EPC STORMWATER REVIEW COMMENTS ARE SHOWN IN ORANGE BOXES WITH BLACK TEXT

DRAWN BY: O.E. WATTS DATE: 1-20-20 DWG. NO.: 19-5348-05 SURVEYED BY: DEW, ESW, 6-26-19	APPROVED BY: PROJ. NO.: DWG.:	REVISIONS 7-28-20 REVISED PER COUNTY REVIEW COMMENTS DEW	OLIVER E. WATTS CONSULTING ENGINEER COLORADO SPRINGS	PROJECT 10634 & 10658 MALTESE POINT LOTS 2 & 3, ROLLING THUNDER BUSINESS PARK EL PASO COUNTY	SHEET NAME GRADING AND EROSION CONTROL PLAN	SHEET NO. 1 OF 2
---	-------------------------------------	--	--	---	---	---------------------

6" CURB
1/2"=1'-0"

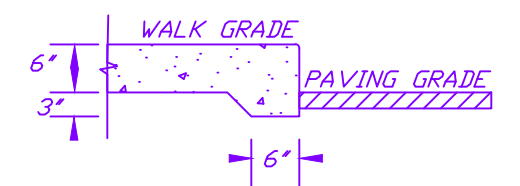
Review 1 comment: Please label the proposed curb and gutter throughout the site and provide a detail.
Review 2: Unresolved.
Review 3: Unresolved. Please provide labels on the plan so that it is clear where a curb is proposed.

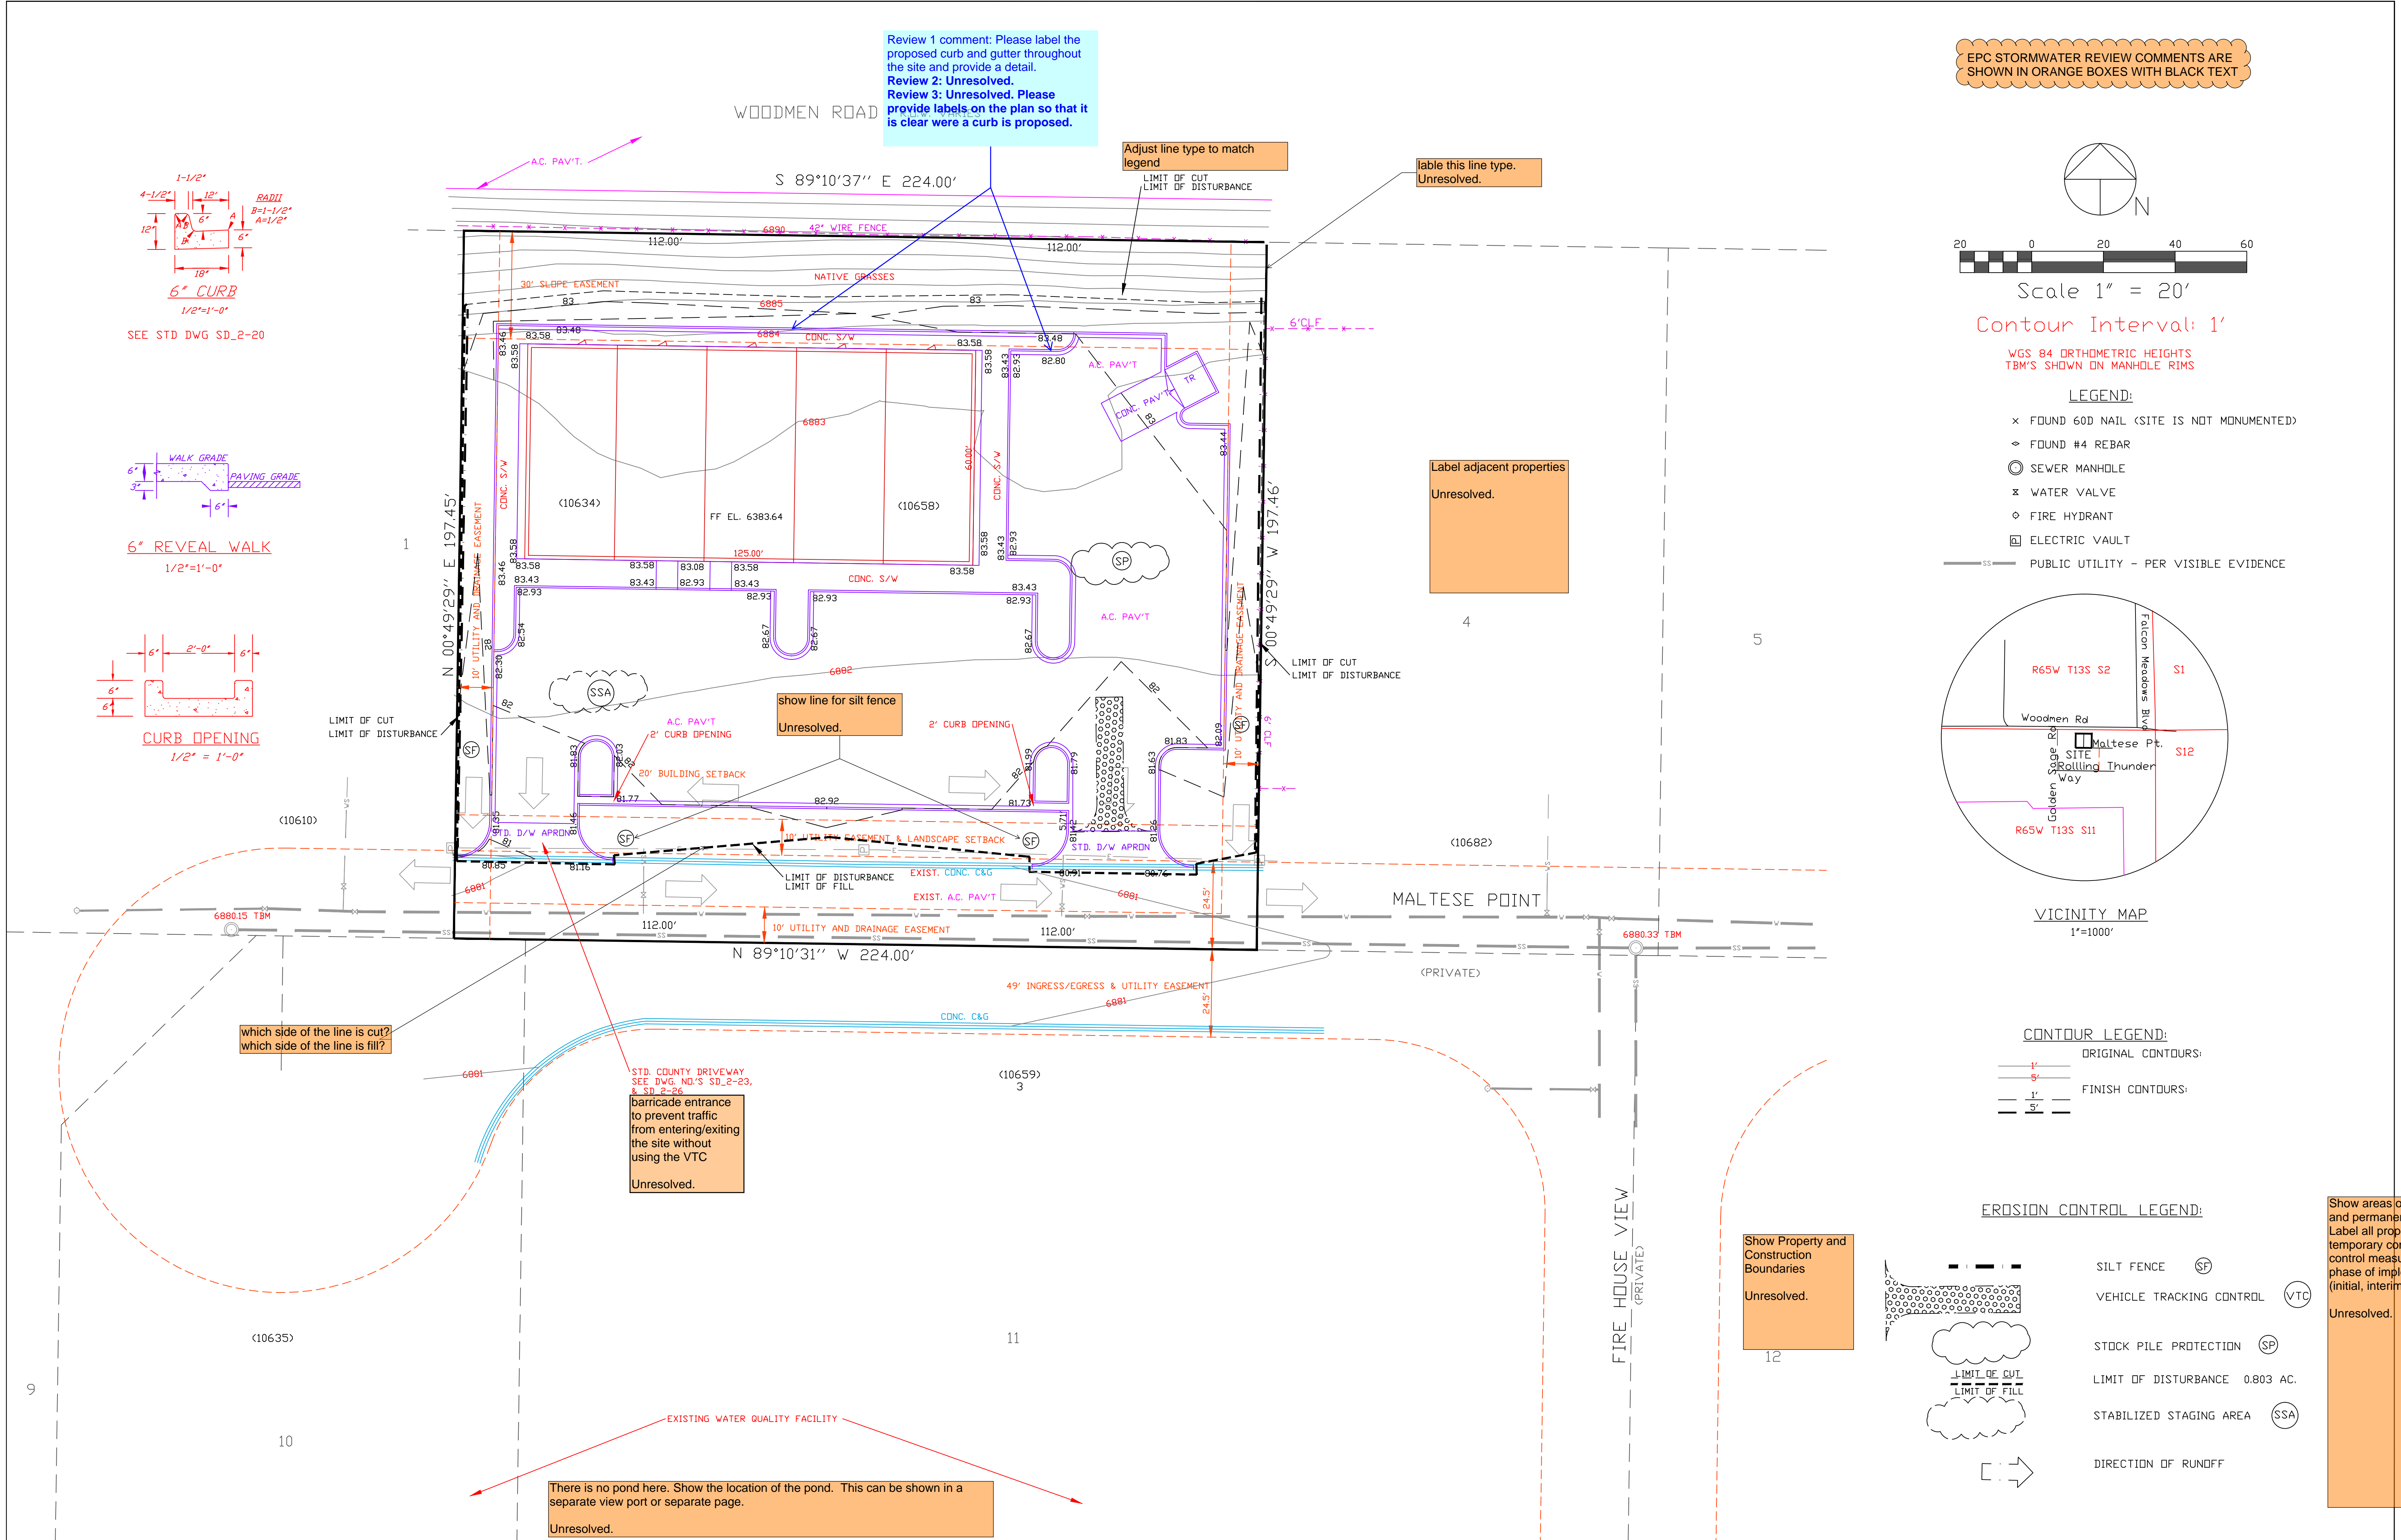
Adjust line type to match legend
LIMIT OF CUT
LIMIT OF DISTURBANCE

Label this line type.
Unresolved.

Label adjacent properties
Unresolved.

show line for silt fence
Unresolved.

which side of the line is cut?
which side of the line is fill?

STD. COUNTY DRIVEWAY
SEE DWG. NO.'S SD_2-23,
& SD_2-24
barricade entrance to prevent traffic from entering/exiting the site without using the VTC
Unresolved.

There is no pond here. Show the location of the pond. This can be shown in a separate view port or separate page.
Unresolved.

Show Property and Construction Boundaries
Unresolved.

Show areas of temporary and permanent seeding
Label all proposed temporary construction control measures by phase of implementation (initial, interim, final).
Unresolved.
